Final Drainage Report

Waterview East Commercial El Paso County, Colorado

Project #: 196195000

PCD Filing No.: SP-22-009

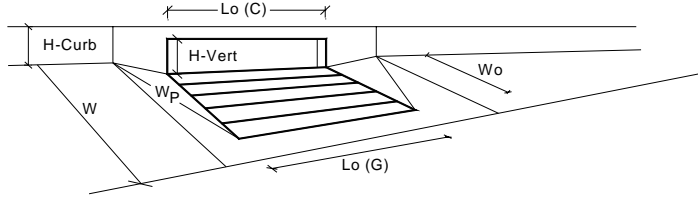
Include back in from last report,
analysis of existing inlet in
Frontside Drive.
